GRADING AND EROSION CONTROL PLAN
APPALOOSA HIGHWAY 24 SUBDIVISION FILING NO. 2
EL PASO COUNTY, COLORADO

APPALOOSA HIGHWAY 24 SUBDIVISION
FILING NO. 1A
COLORADO SPRINGS, COLORADO
COVER SHEET

Markup Summary

OUTLET STRUCTURES DETAILS
NOT TO SCALE

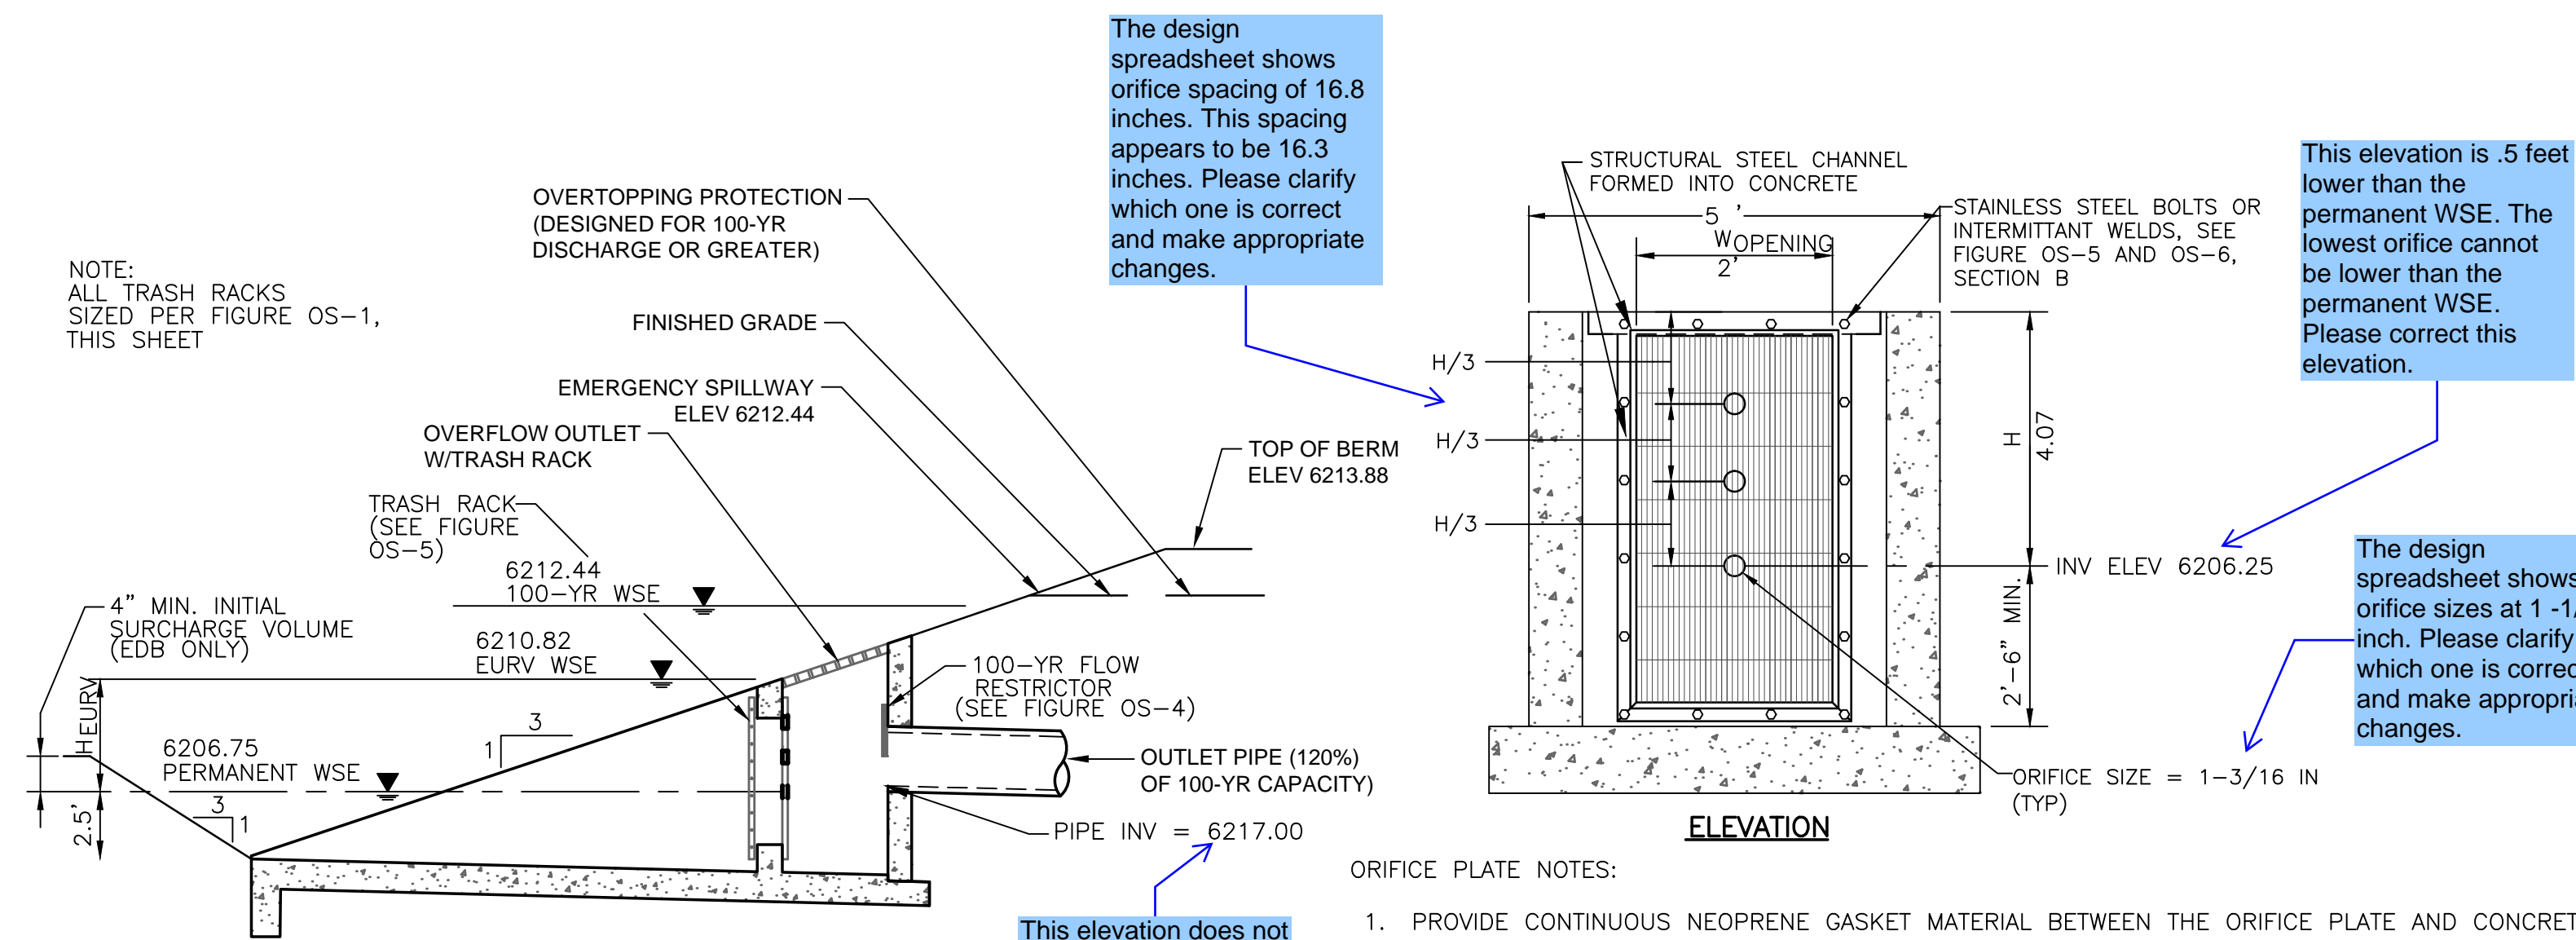
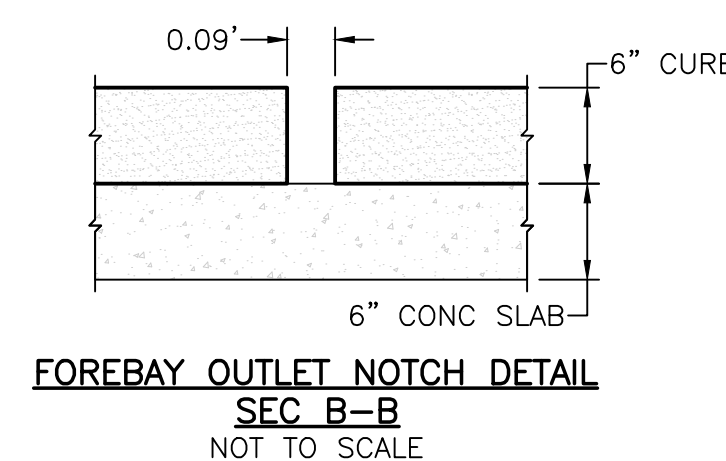
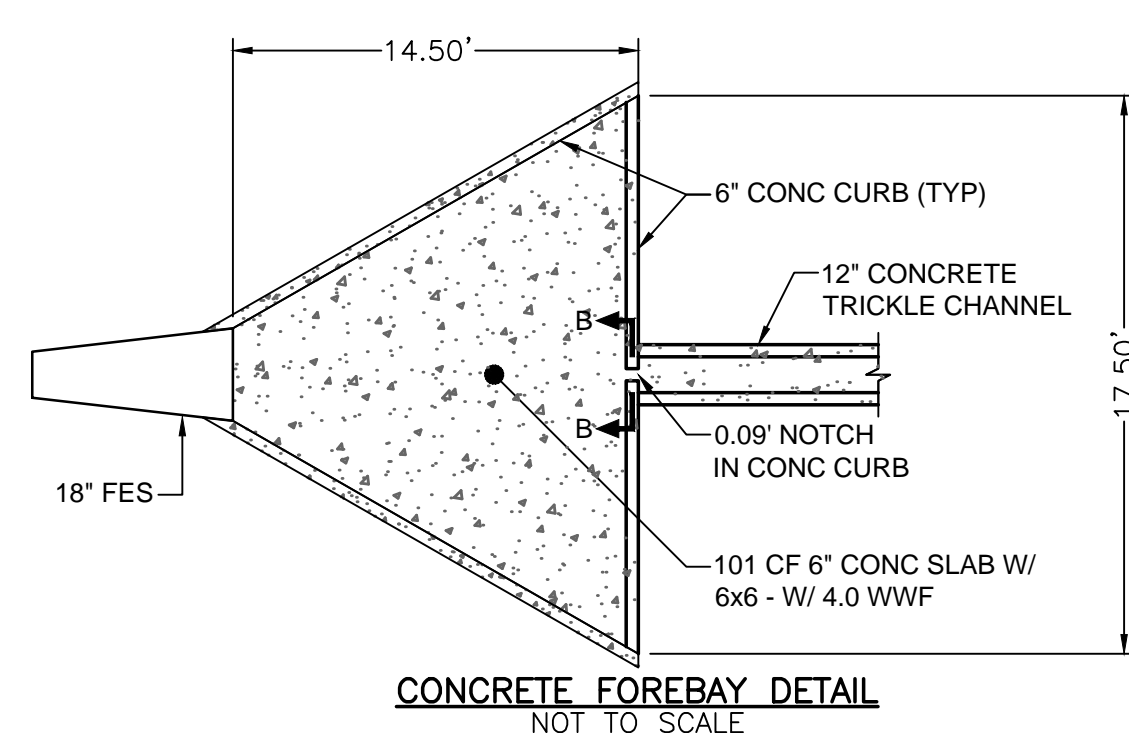
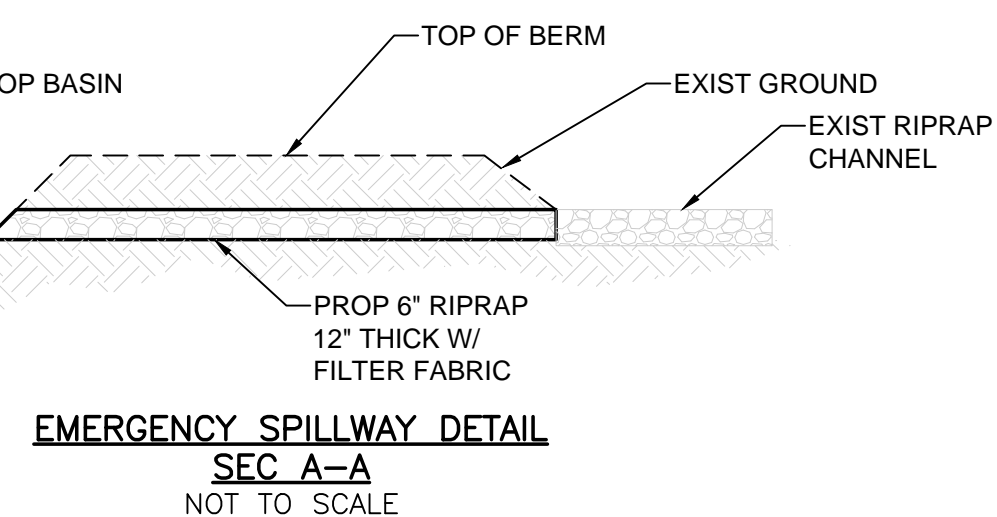
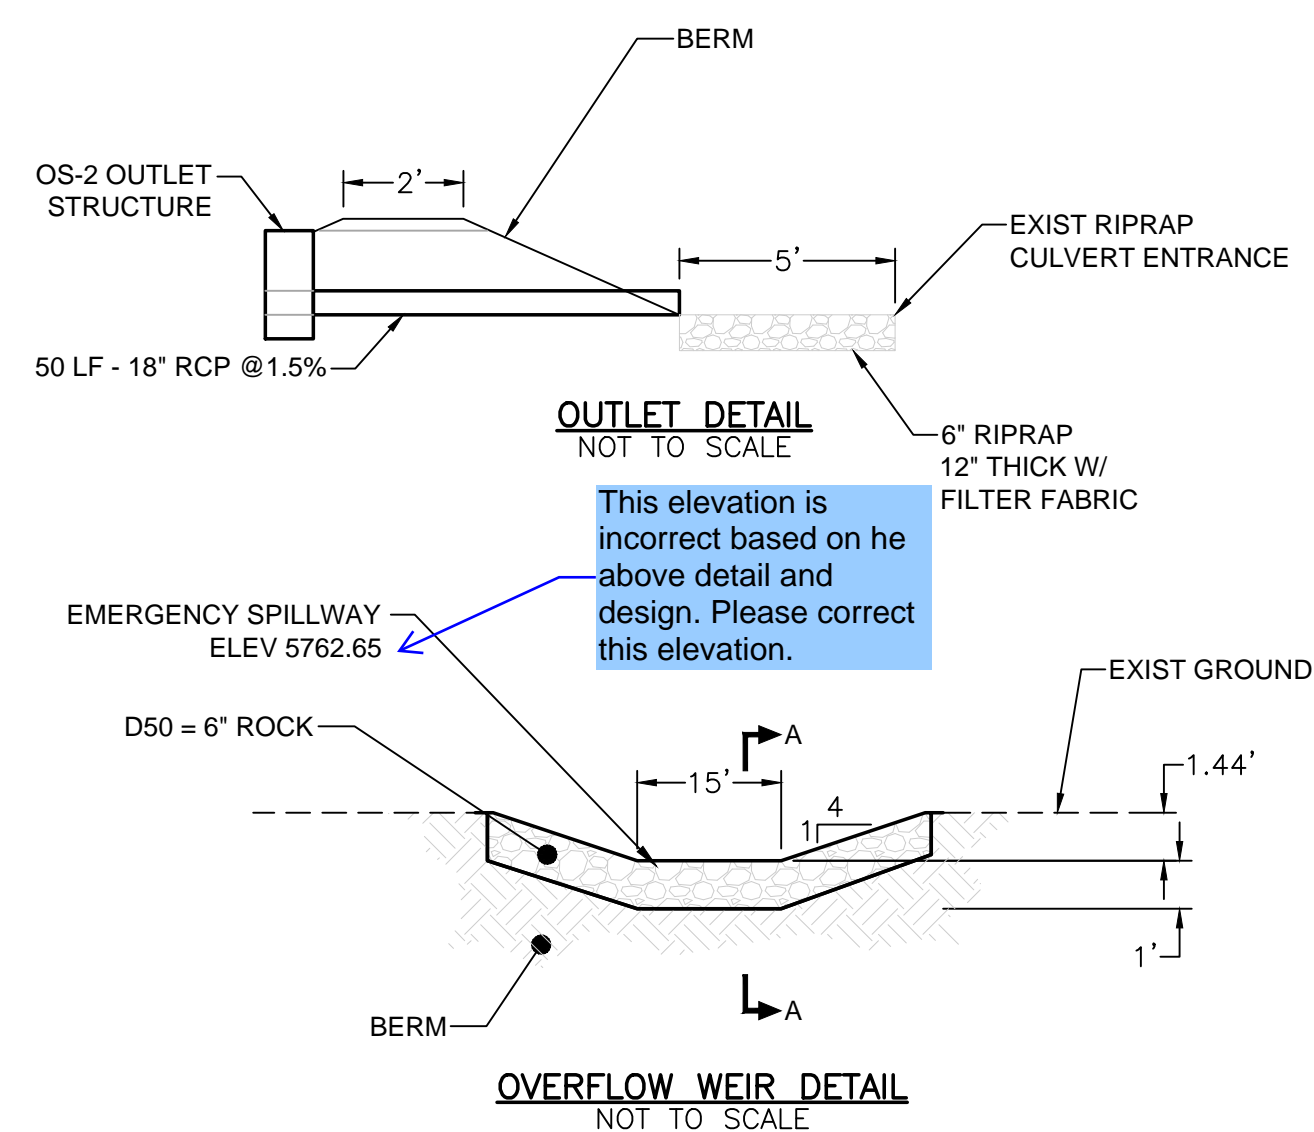
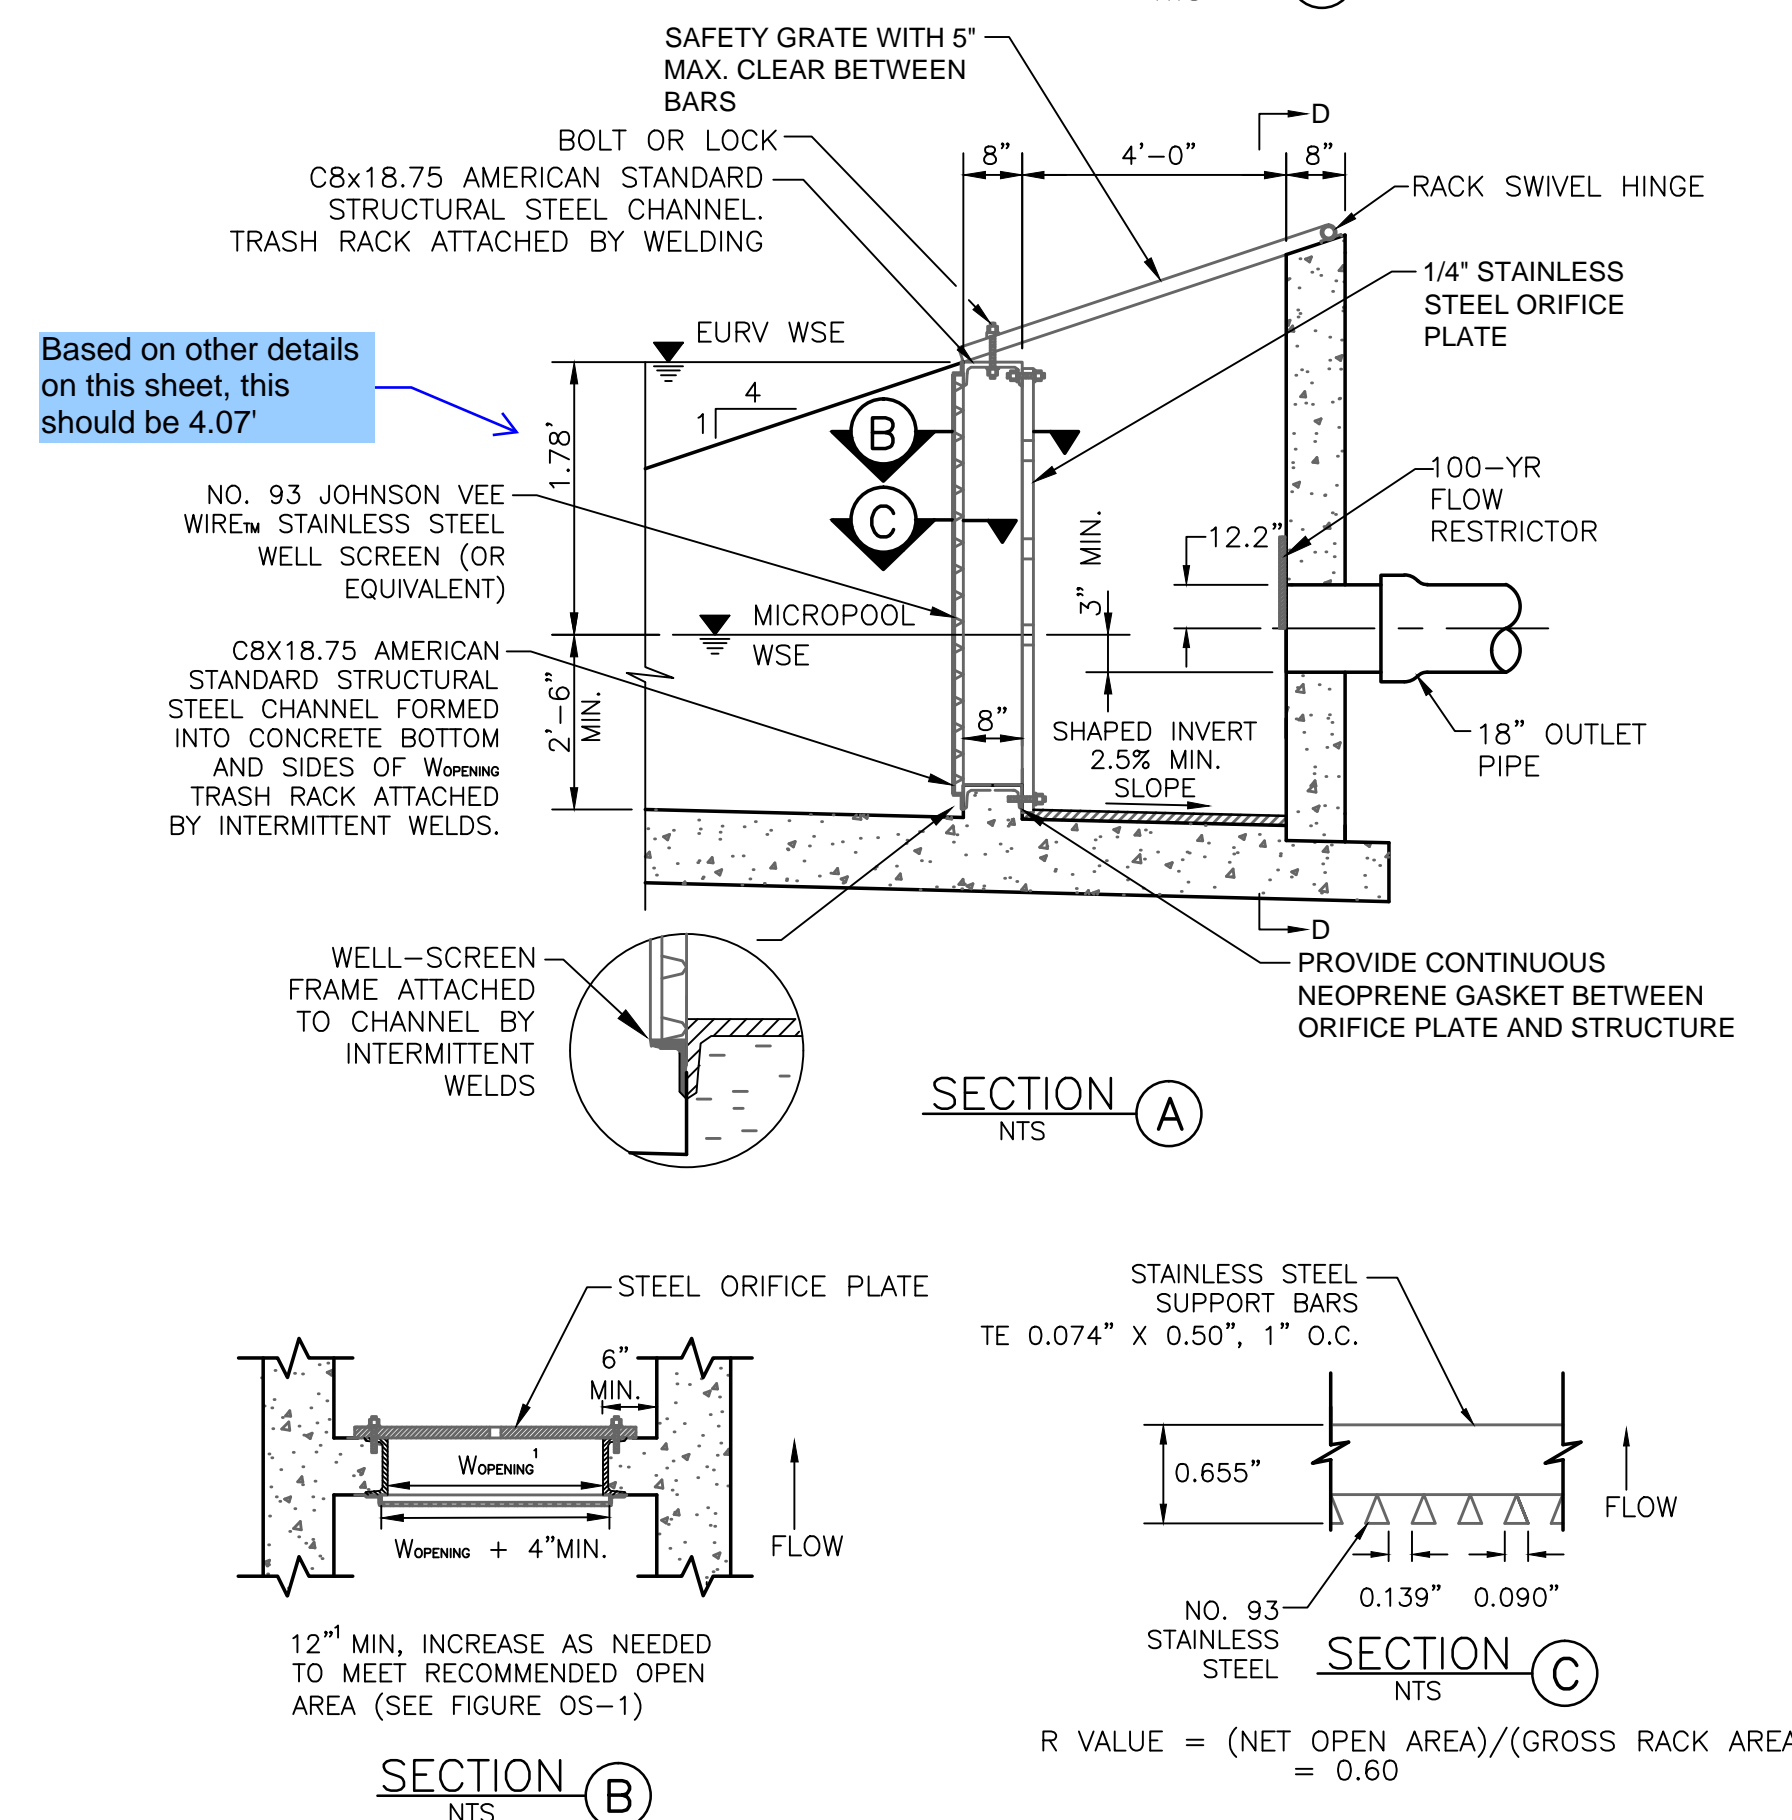
Based on other details on this sheet, this should be 4.07'

This elevation does not appear to be correct. Please revise to provide an accurate elevation of the outlet pipe.

Pipe invert elevation cannot be greater than Permanent WSE.
